Project	<b>IEEE 802.16 Broadband Wireless Access Working Group</b> < <a href="http://ieee802.org/16">http://ieee802.org/16</a> >	
Title	Relay Station Handover Procedure	
Date Submitted	2007-03-12	
Source(s)	Hang Zhang, Peiying Zhu, Mo-Han Fong, Wen Tong, David Steer, Gamini Senarath, Derek Yu, Mark Naden, G.Q. Wang  Nortel 3500 Carling Avenue Ottawa, Ontario K2H 8E9	Voice: +1 613 7631315 <a href="mailto:WenTong@nortel.com">[mailto:WenTong@nortel.com]</a>  <a href="mailto:pyzhu@nortel.com">[mailto:pyzhu@nortel.com]</a>
Re:	A response to a Call for Technical Proposal, <a href="http://www.ieee802.org/16/relay/docs/80216j-07_007r2.pdf">http://www.ieee802.org/16/relay/docs/80216j-07_007r2.pdf</a>	
Abstract	This contribution proposes RS handover procedure which is required when an RS migrates from the air-interface provided by one access station to the air-interface provided by another access station due to radio environment change or topology change, etc.

## **Relay Station Handover Procedure**

3.1 Text change for RS HO description

Figure XXX. RS HO process

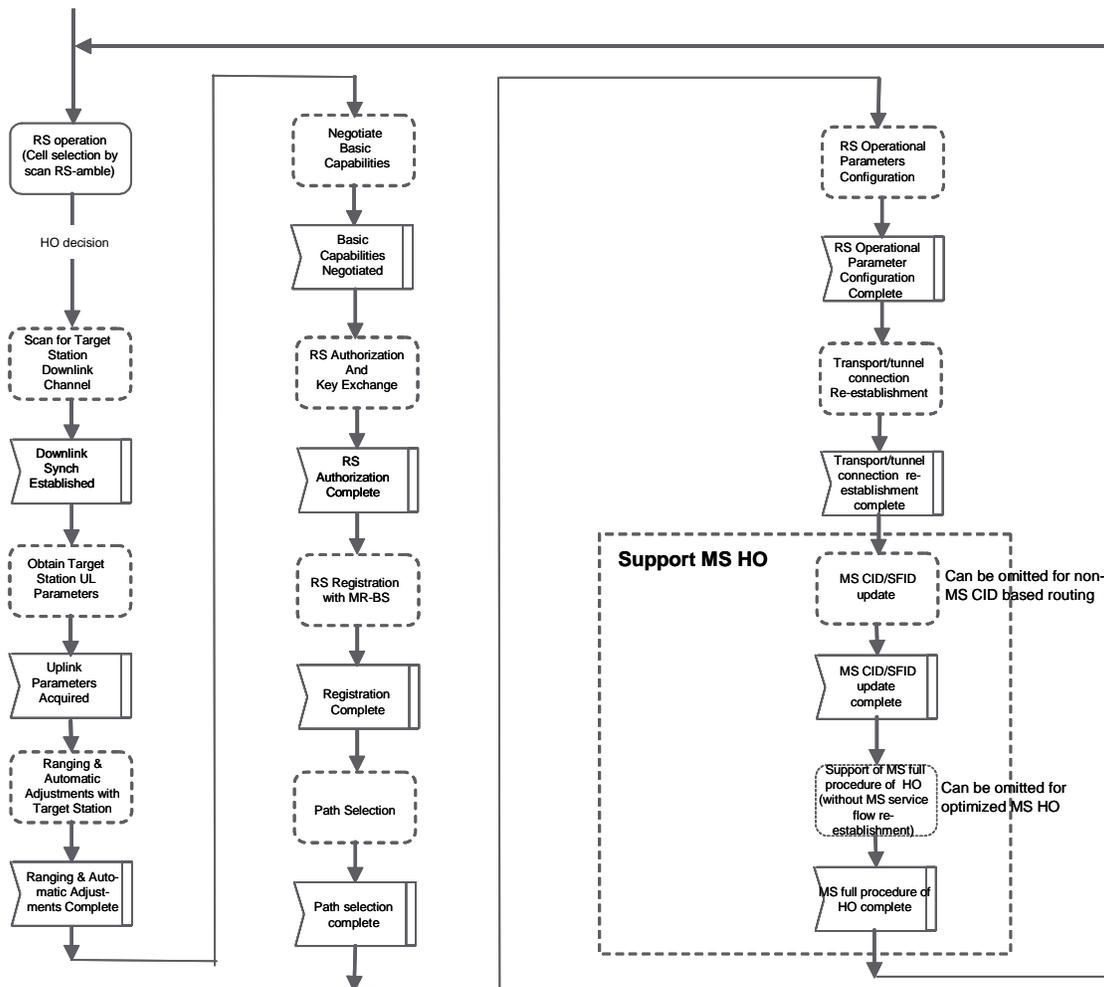
*[Replace section 6.3.22.4 with the following]*

6.3.22.4. RS handover

This section defines the RS HO process in which an RS migrates from the air-interface provided by one access station to the air-interface provided by another access station. The RS HO process is depicted in Figure xxx.

The RS HO process consists of stages of MS HO process and following additional stages

- Path selection – This stage enable the target MR-BS to indicate a path re-reselection. The target MR-BS may decide to skip this step if the bit #0 in RS HO optimization TLV of MOB\_BS\_RSP/REQ is set

- RS operational parameter configuration – This stage enable the target MR-BS to reconfigure RS operational parameters. The target MR-BS may decide to skip tis step if the bit #1 in RS HO optimization TLV of MOB\_BS\_RSP/REQ is set

- Tunnel/connection re-establishment – this stage enable the target MR-BS to re-establish connection/tunnel for a RS. The target MR-BS may decide to skip this step if the bit #2 in RS HO optimization TLV of MOB\_BS\_RSP/REQ is set

- Support of MS HO stage is not required for RS in MBS mode and needed only for RS in MRS mode. This stage includes two sub-stages:
  - o Support of MS service flow re-establishment – This step is required only if MS CID based data forward is in use. In this case, this stage is used for the target MR-BS to inform the requesting RS regarding the CID/SFID updates of associated MSs/RS. For non-MS CID based data forwarding schemes, this step can be omitted. In this case, there is no MS CID/SFID is required. Since for DL data packet forwarding after the RS HO, the MR-BS can route the DL data packet of MSs associated with the RS to the tunnel/basic connection of this RS and no MS CID collision would happen.

- o Support full set of MS HO – This sub-stage can be omitted if optimized HO is possible. For non-optimized MS HO, the MS service flow re-establishment can always be omitted for non-MS CID based routing; for MS CID based forwarding, the RS may use CID swapping to avoid involvement of MS regarding the MS service flow re-establishment.
